ERRATA for
PE Mechanical Engineering: HVAC and Refrigeration Practice Exam
ISBN: 978-1-932613-76-6
Copyright 2016
Errata posted 11/30/2017

Question 136, p. 30:

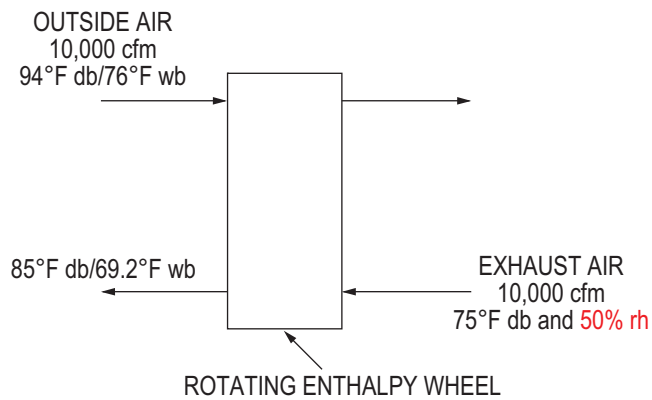
A building air-conditioning system requires 10,000 cfm of outside air for ventilation. An enthalpy wheel, as shown, exchanges both sensible and latent heat energy to reduce the design load on the building refrigeration system. If the enthalpy wheel has 2% losses, the reduction in design load (tons) on the refrigeration system is most nearly:

- (A) 8.4
- (B) 19.1
- (C) 24.4
- (D) 54.2

Solution 136, p. 84:

Using sea level psychrometric chart:

$$Q_{in(EXH)} = 4.5 \times \text{cfm} \times \Delta h;$$

$$h \text{ of } 85^\circ\text{F db}/69.2^\circ\text{F wb} = 33.4 \text{ Btu/lb};$$

$$h \text{ of } 75^\circ\text{F db and } 50\% \text{ rh} = 28.2 \text{ Btu/lb}$$

$$Q_{in(EXH)} = 4.5 \times 10,000(33.4 - 28.2) = 234,000 \text{ Btu/hr}$$

$$= \frac{234,000 \text{ Btu/hr}}{12,000 \text{ Btu}/(\text{hr-ton})} = 19.5 \text{ tons}$$

$$Q_{out(OA)} = 0.98 \times 19.5 = 19.1 \text{ tons}$$

THE CORRECT ANSWER IS: (B)

Question 506, p. 40:

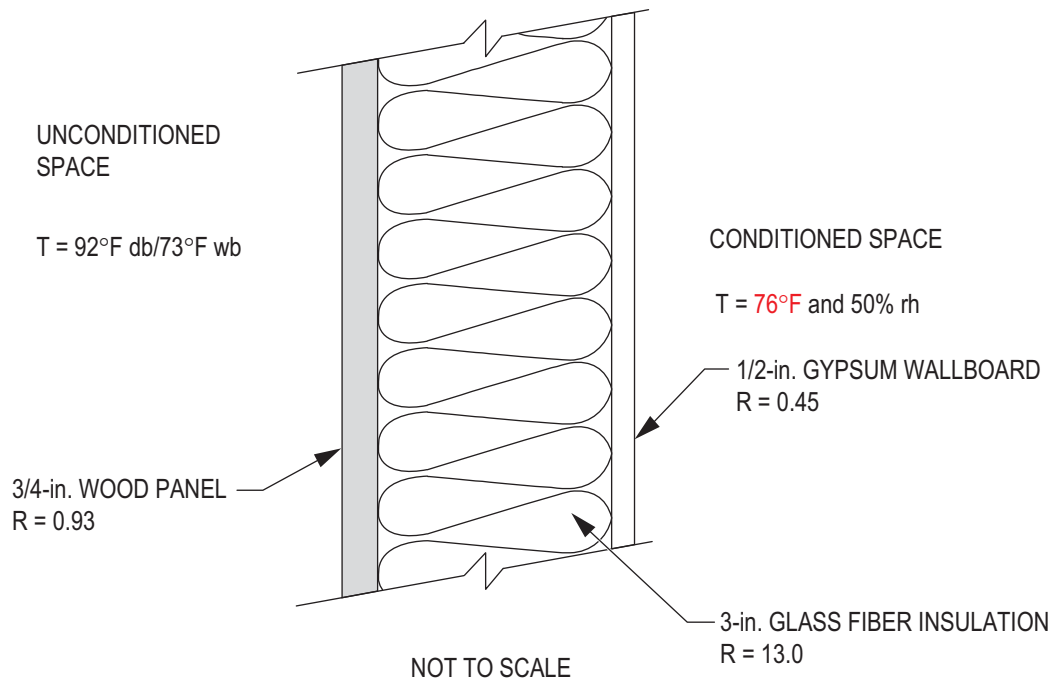
The figure should be shown as follows:
